Construction Change Directive

(name, address)
ALBERTSONS #2250
WICHITA, KANSAS

DIRECTIVE NO.: S-04

ALBERTSON'S - WICHITA, KS

C311.4-4

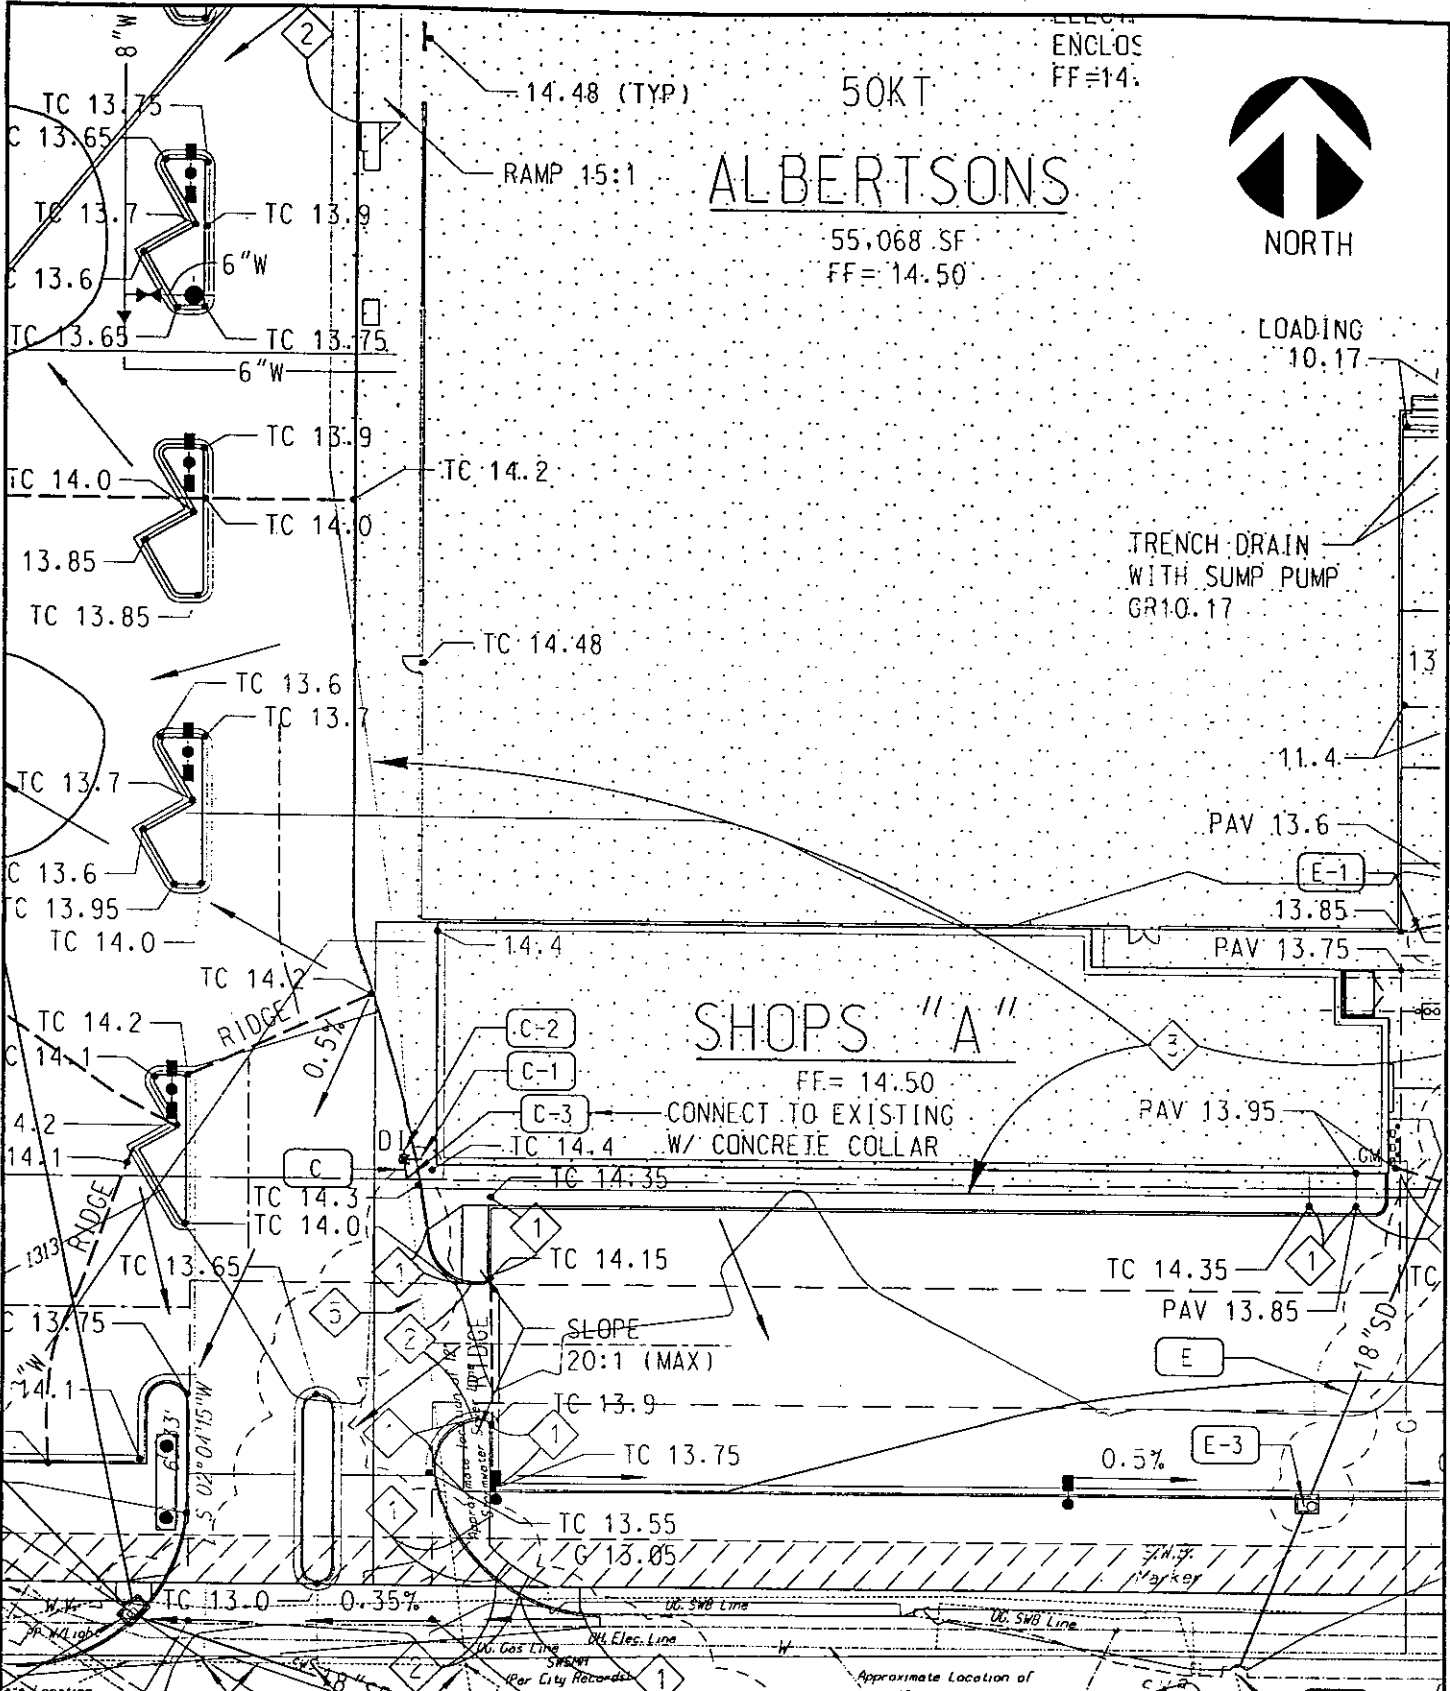
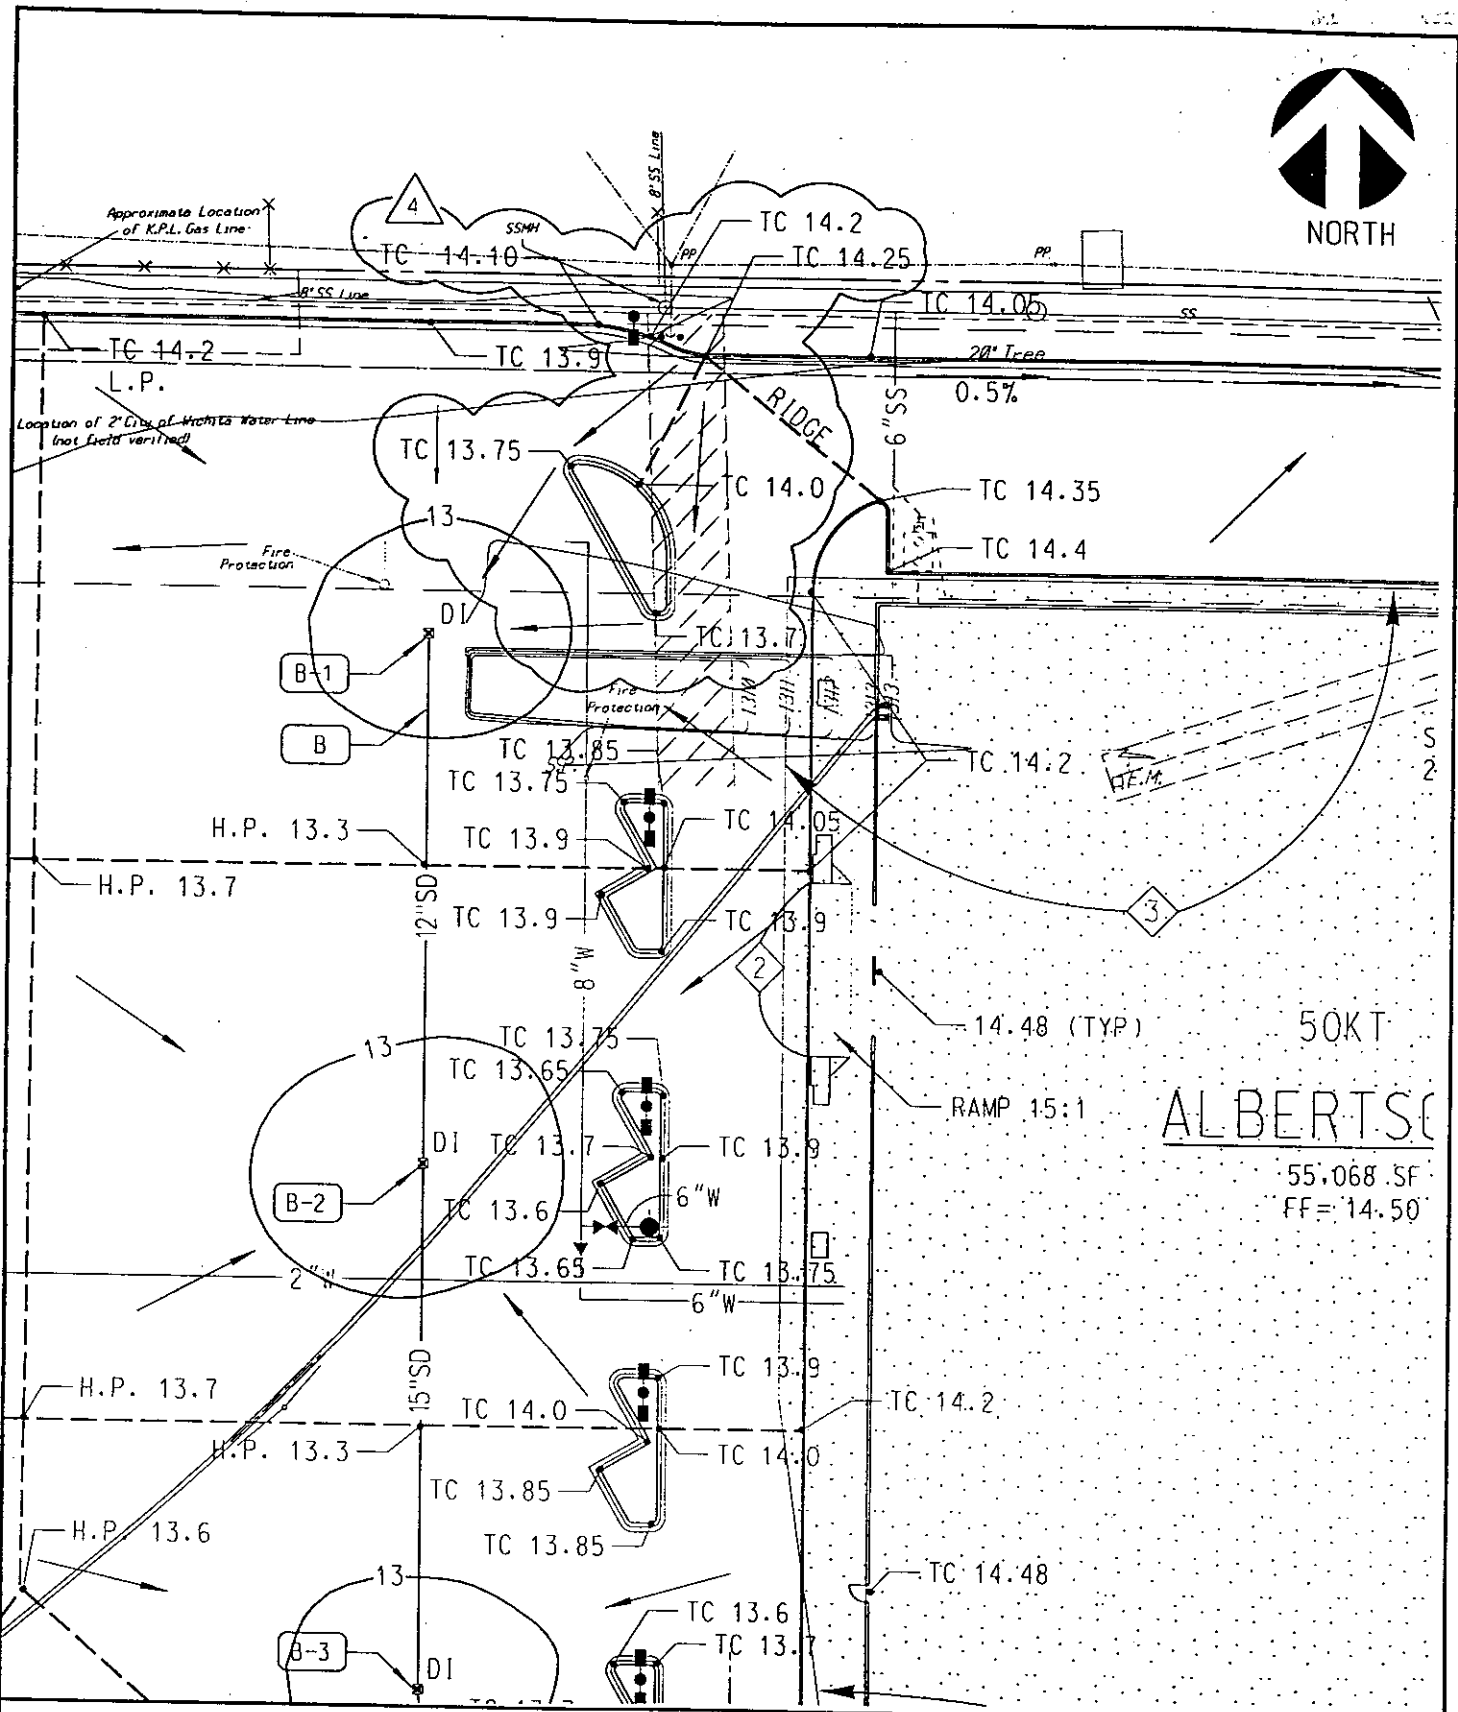
C311, GRADING AND DRAINAGE PLAN

1. Added ~~two~~ *three* (3) grated drop inlets (Points R-1, R-2 & A-1) and related storm drain system (Point R-1 to A-1), replacements for the existing storm drain system (Line R), which was crushed by demolition / construction activities. Refer also to the Summary of Drainage Structures.

2. Revised parking lot grades to create additional cover over the replacement storm drain system (Line R), which was crushed by demolition / construction activities.

3. Per D.J. Christie's instruction, deleted Storm Drain Line C from previous Point C-1 to Point C-3 and relocated Points C-1 and C-2; revised the size, length and slope from C-1 to C-2, as well as revised the pipe length and slope from C-2 to C-3. Refer also to the Summary of Drainage Structures.

SHEET NUMBER **C311.4-5**

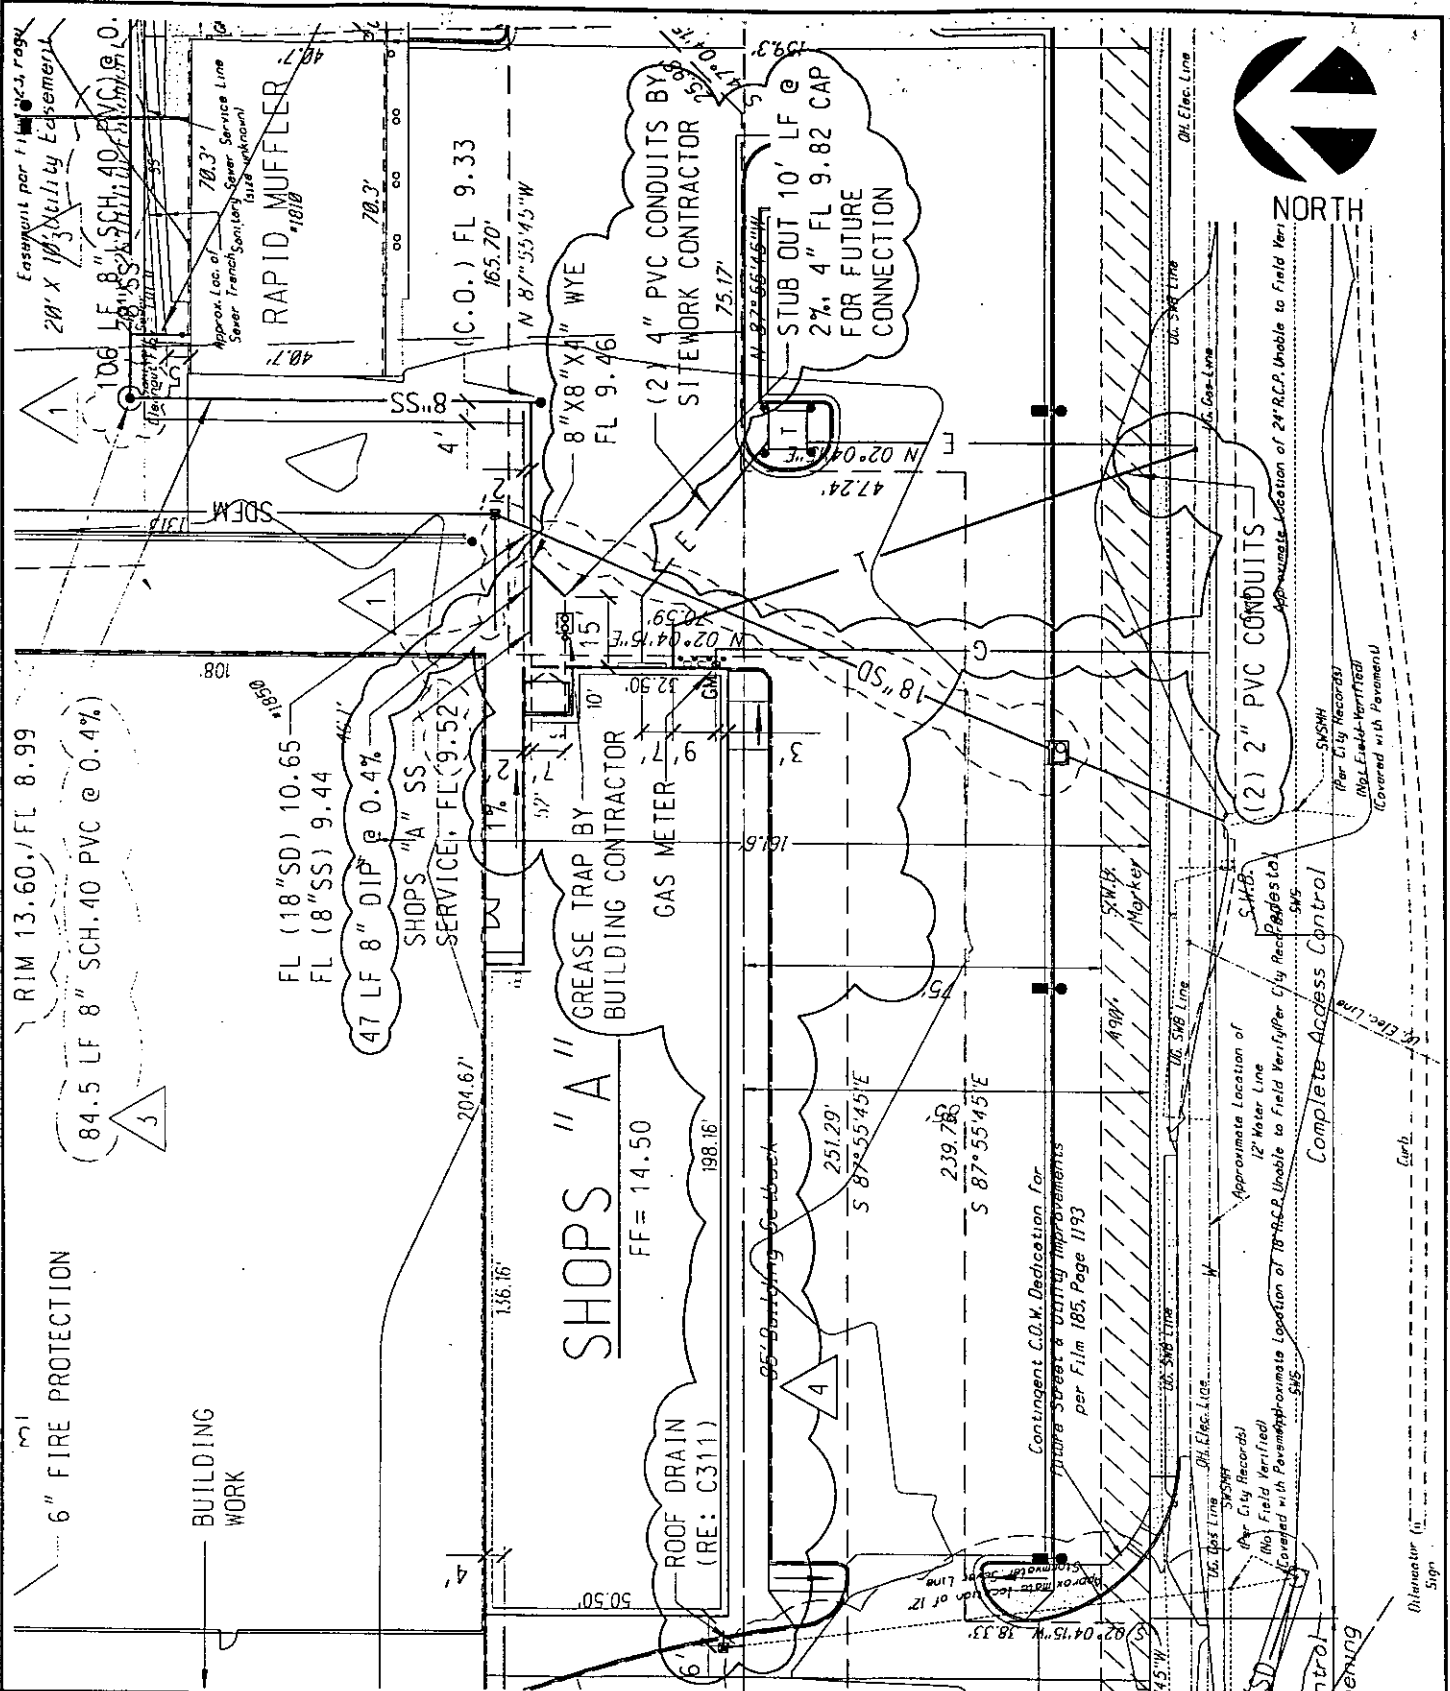
4. Corrected three grades just north of the liquor store and add one that was missing.
5. Revised grades along the northerly curb and at the island at the east end of the most northerly group of angled parking stalls, where the utility pole guy relocation would not clear original alignment.

DESIGNED BY MNP	JOB NUMBER 27000038.250
APPROVED BY PTA	STORE NUMBER 2250
DATE 7/3/97	SCALE 1" = 20'
SHEET NUMBER LS102.4-1

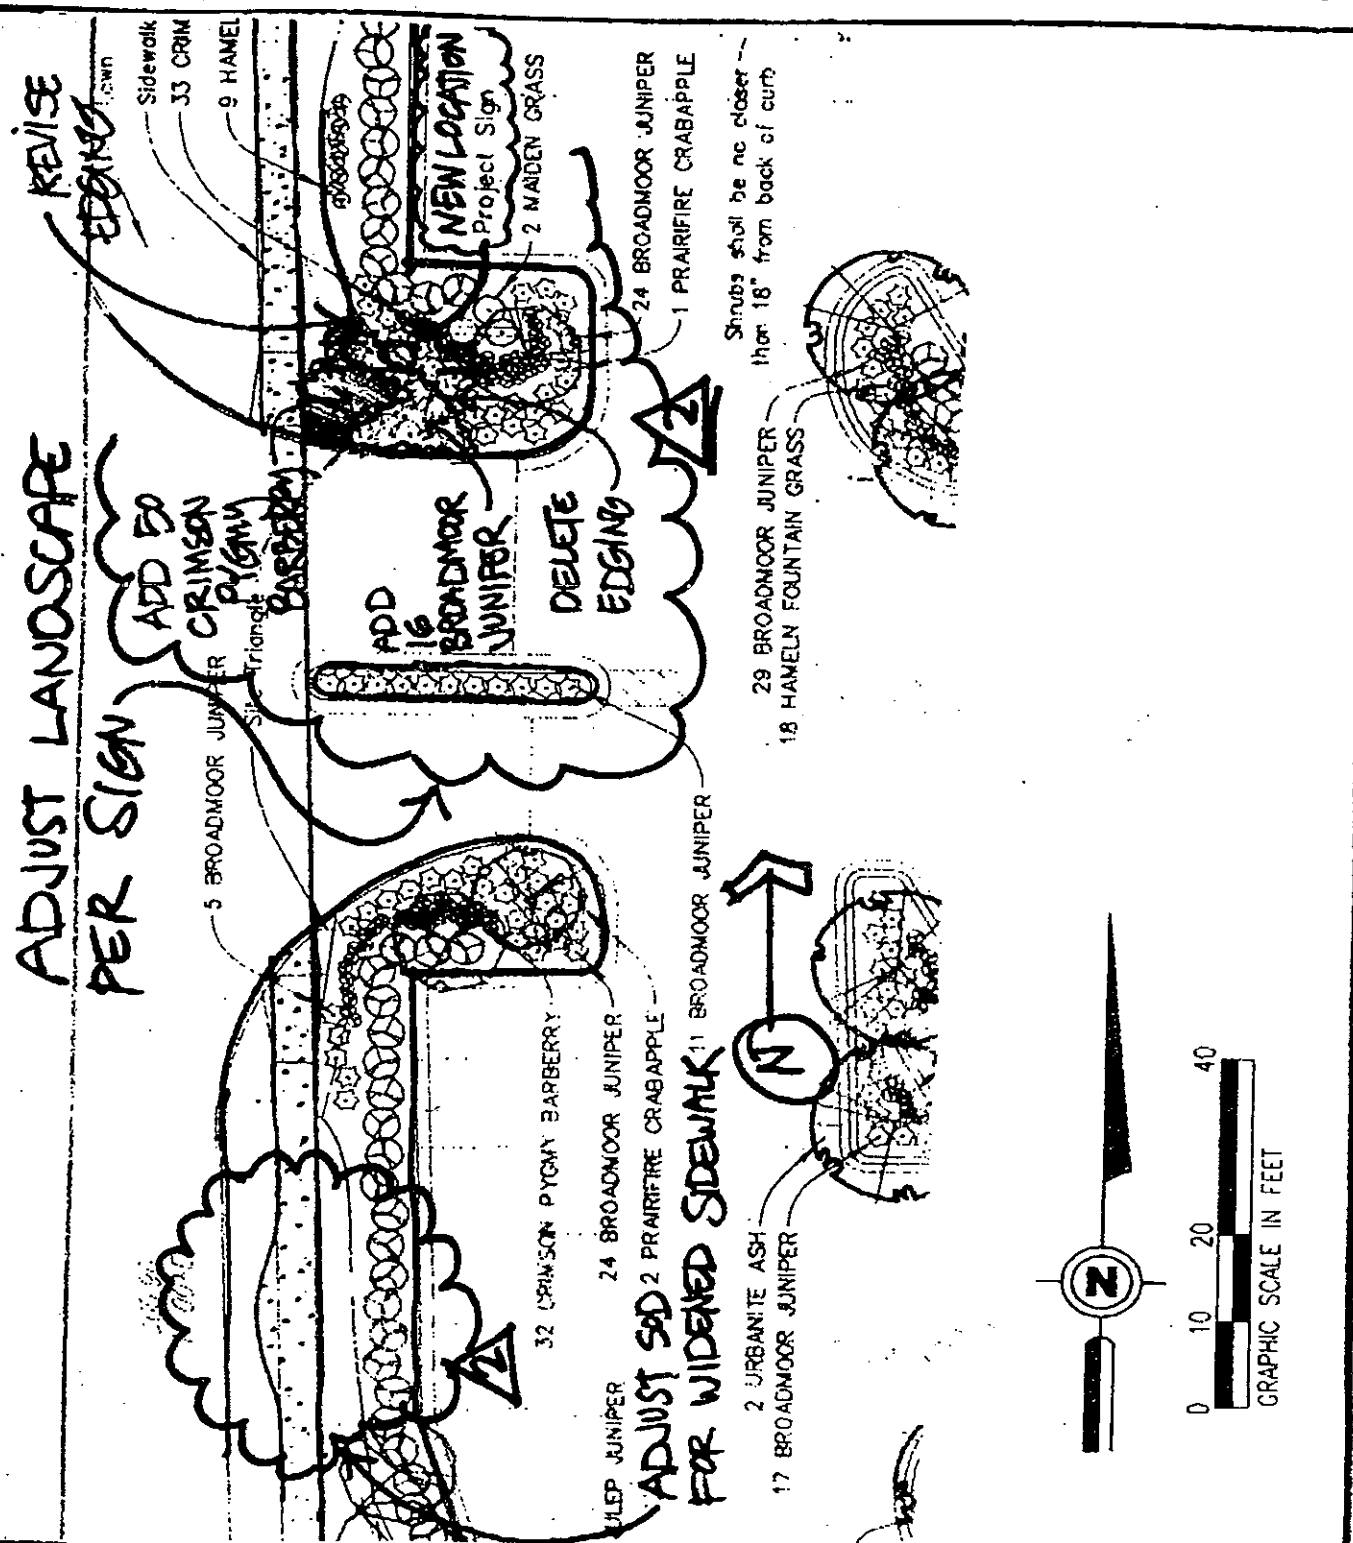
LS102, LANDSCAPE PLAN

1. Made adjustments for the pylon sign relocation.
2. Made adjustments for the joint tenant sign relocation.
3. Made adjustments for the sidewalk widening at the two existing fire hydrants along Amidon.
4. Made adjustments for the northerly curb and island modifications.
5. Made adjustments for the joint tenant sign relocation.

ADJUST LANDSCAPE PER SIGN

REVISE EDGING

DESIGNED BY MNP	JOB NUMBER 27000038.250
APPROVED BY PTA	STORE NUMBER 2250
DATE 7/3/97	SCALE 1" = 20'
SHEET NUMBER LS102.4-2

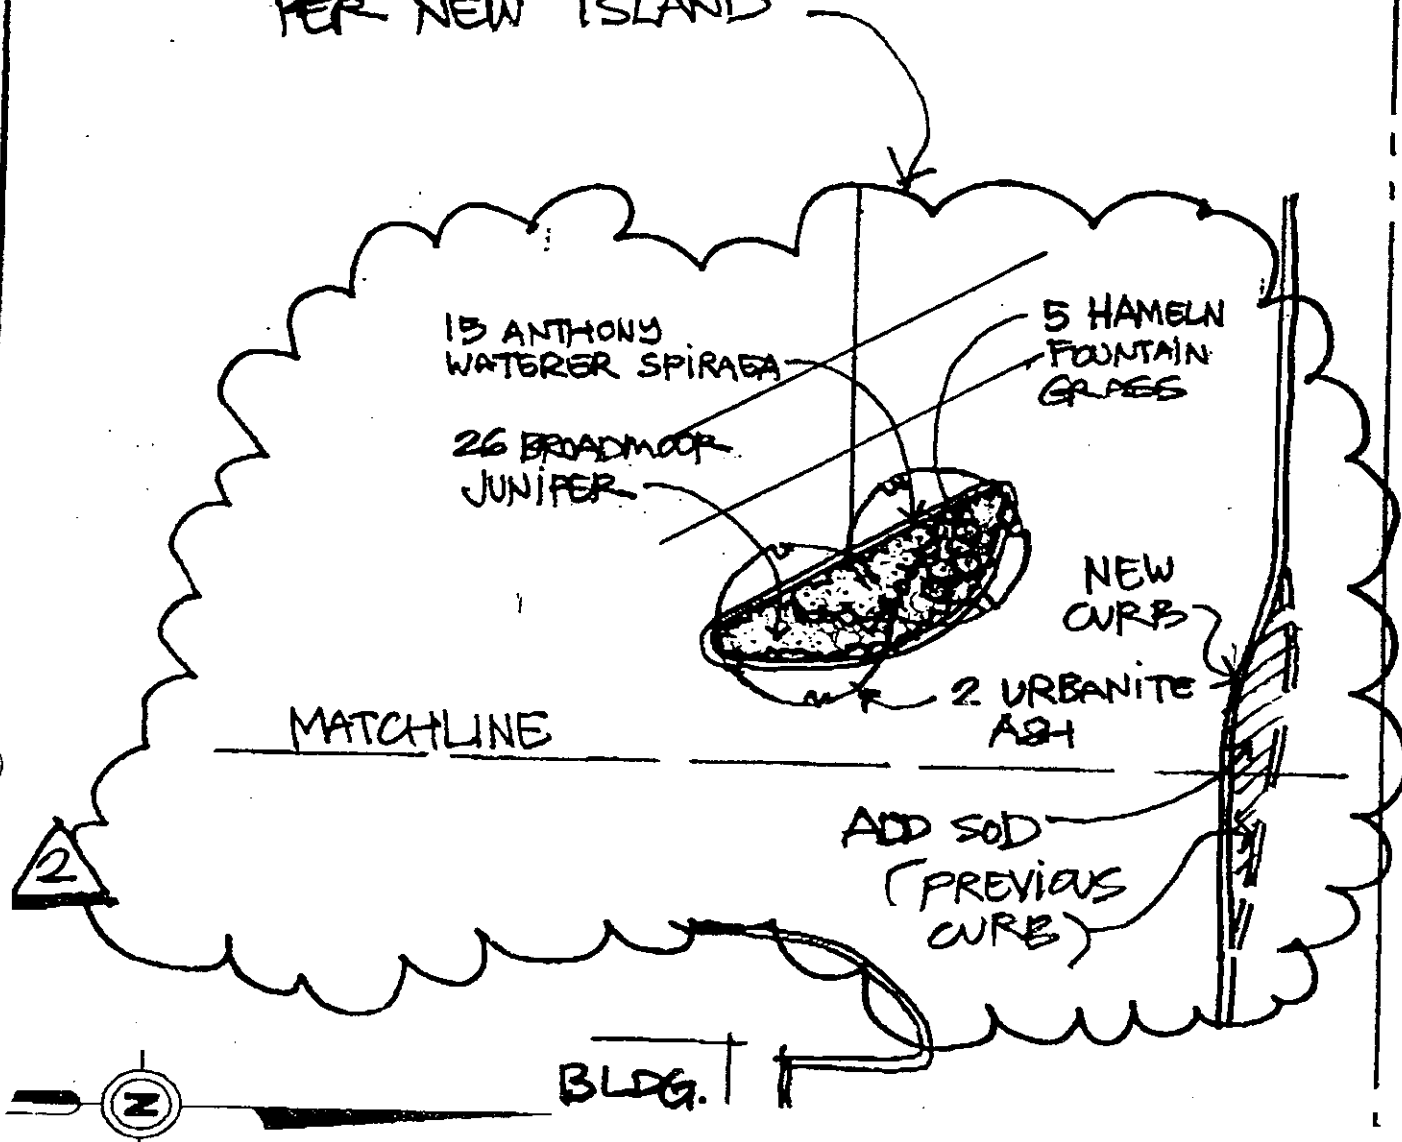
REVISE LANDSCAPING PER NEW ISLAND
